UNITED STATES PATENT AND TRADEMARK OFFICE

| APPLICATION NO. | FILING DATE | FIRST NAMED INVENTOR | ATTORNEY DOCKET NO. | CONFIRMATION NO. |
|-----------------|-------------|----------------------|---------------------|------------------|
| 10/088,533 | 08/19/2002 | Ralf Christoph | 02051 | 3044 |

| Office Action Summary | Application No. 10/088,533 | Applicant(s) CHRISTOPH ET AL. | |

DETAILED ACTION

FIGURE 3

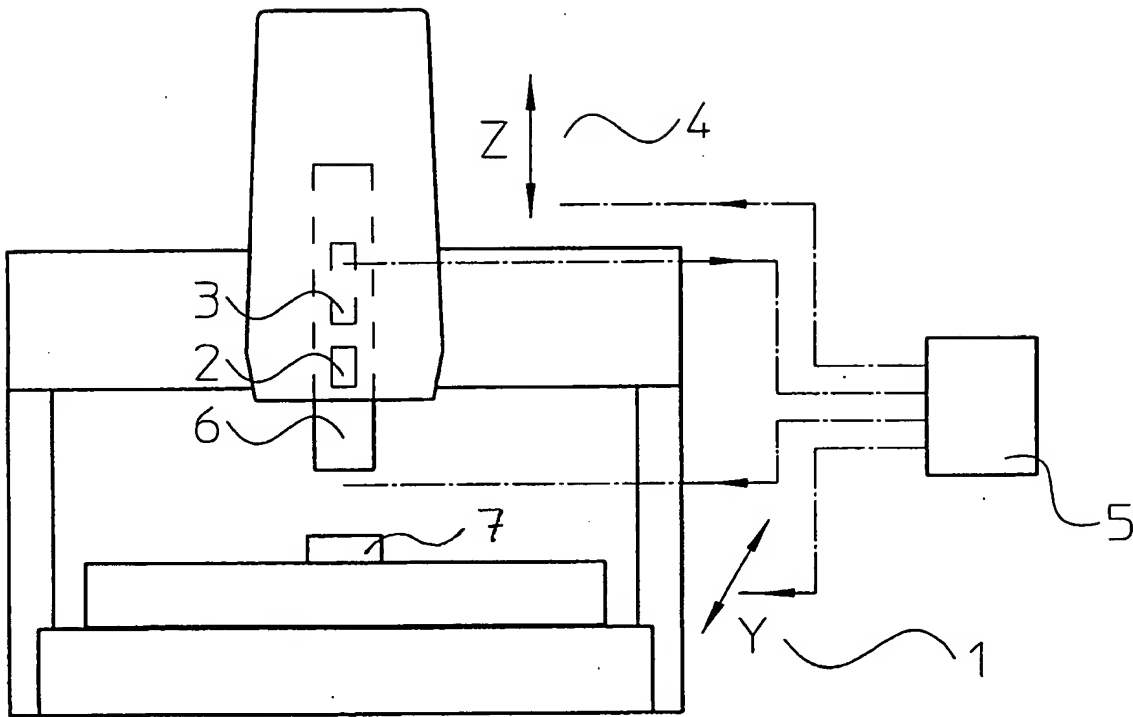
2. The drawings filed on 6/7/05 have not been entered because: (1) figure 3 has nothing to do with the drawing objection under 37 CFR 1.83 (a) and may introduce new matter to the disclosure; (2) there is no description of figure 3 in the specification; and (3) the drawing sheet must be labeled as "New Sheet" under 37 CFR 1.121 (d).

NOT ENTER!
HP
6/16/05
